Access Compliance Report

Public Rights-of-Way

Intersection ID: 54364	Main Street: GANNON_DR	Cross Street: BEREWICK_TOWN_CENTER_DR	Location: SW
ADA ID: B0F8DD58CDBA	Ramp Type: Perp	Initial Pass/Fail: Pass	Overall Compliance: No
Severity Score: 0			
Codes/Mitigation Info/Possible Solution		Field Measurements/Component Compliance

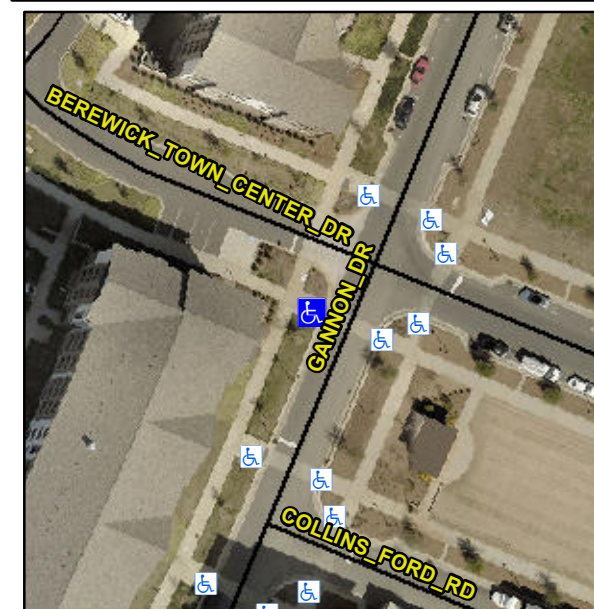
Compliance	Description	Data	Compliance	Description	Data
N/A	Ramp Length (in)	83.0	Yes	Ramp Slope (%)	5.1
Yes	Ramp Width (in)	94.0	Yes	Ramp XSlope (%)	1.7
Yes	Flare Type L	Curbed_NoWalkSurface	Yes	Flare Type RT	N/A
Yes	Flare Slope LT (%)	N/A	N/A	Flare Slope RT (%)	N/A
N/A	Flare Traversable LT?	No	N/A	Flare Traversable RT?	No
Yes	Landing Length (in)	101.0	Yes	DWS Provided?	Yes
Yes	Landing Width (in)	94.0	Yes	DWS Contrast?	Yes
No	Landing Slope (%)	4.2	Yes	DWS Length (in)	24.0
Yes	Landing X Slope (%)	0.5	Yes	DWS Full Width?	Yes
N/A	Landing Curb? (Y/N)	No	Yes	DWS Offset (in)	0.0
N/A	Shared Landing?	No			
Yes	Gutter Ponding?	No	Yes	Gutter Slope (%)	3.8
Yes	Gutter Lip Ht (in)	0.0	Yes	Gutter X Slope (%)	1.6
N/A	Painted X Walk1?	Yes	N/A	Painted X Walk2?	N/A
	X Walk 1 Direction	To SE		X Walk 2 Direction	N/A
N/A	X Walk 1 Width (in)	97.5	N/A	X Walk 2 Width (in)	N/A
	X Walk 1 Slope (%)	2.6		X Walk 2 Slope (%)	N/A
	X Walk 1 X Slope (%)	1.2		X Walk 2 X Slope (%)	N/A

Yes	Ramp inside XWalk1?	Yes	N/A	Ramp inside XWalk2?	N/A
	Road Slope (%)	N/A	N/A	Clear Space?	Yes
	Road X Slope (%)	N/A	N/A	Clear Space to XWalk (in)	N/A
Yes	Any Obstructions?	No	Yes	Storm Grate/Utility Hazard?	No
	Obstruction Type			Storm Grate/Utility Type	
		N/A			N/A
			Yes	Surface Condition? (G/P)	Good

Possible Solutions:

Remove & Replace Landing.
